**STAFF REPORT:** 08-12-2020 MEETING

**APPLICATION NUMBER:** 20-6760

**ADDRESS:** 1980 EDISON

**SCOPE:** DEMOLISH GARAGE (WDWP); ERECT NEW GARAGE, REBUILD FRONT ENTRY PORTICO AND PORCH PLATFORM

HDAB District Designation Photo, 1974

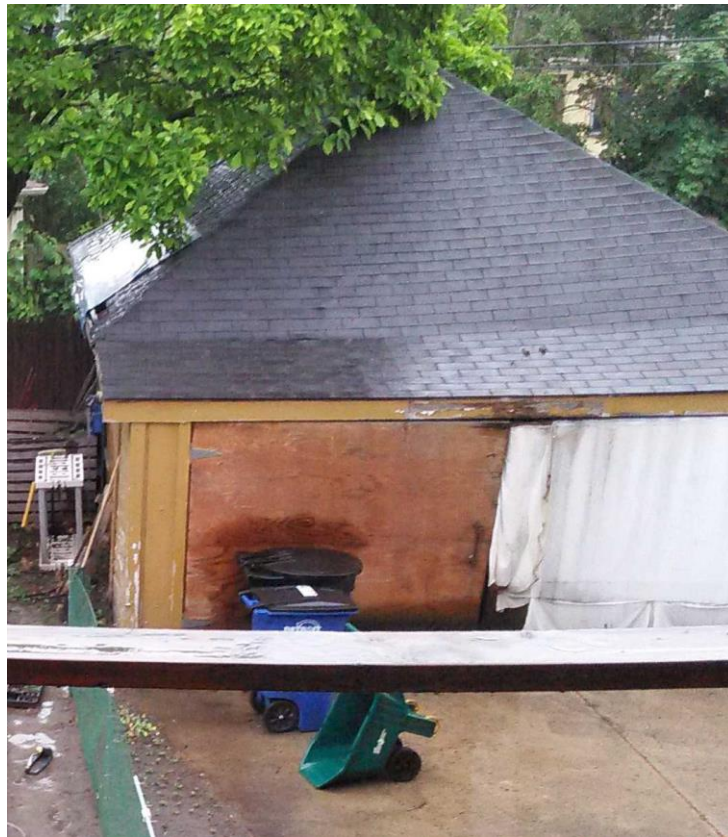
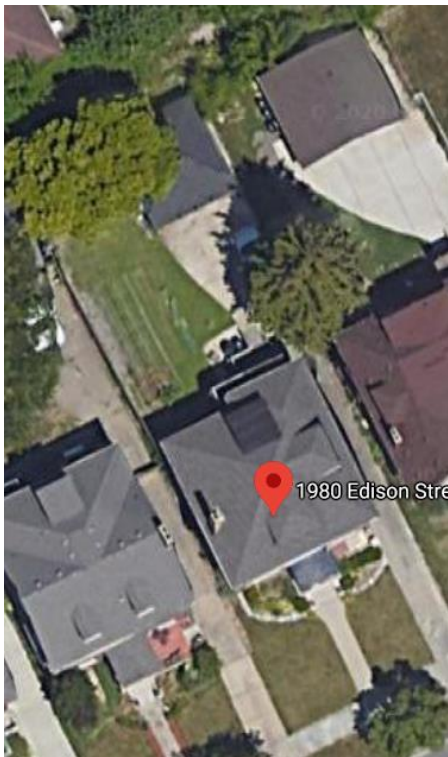
Prior to the district's designation, as evidenced in the above photo, the wood columns that would have supporting the portico had already been replaced with metal columns. The iron columns were still present until their recent removal by the applicant, as shown in the photo on the right. The matching metal ironwork obscuring the keystone lintels of the first floor windows is no longer present.
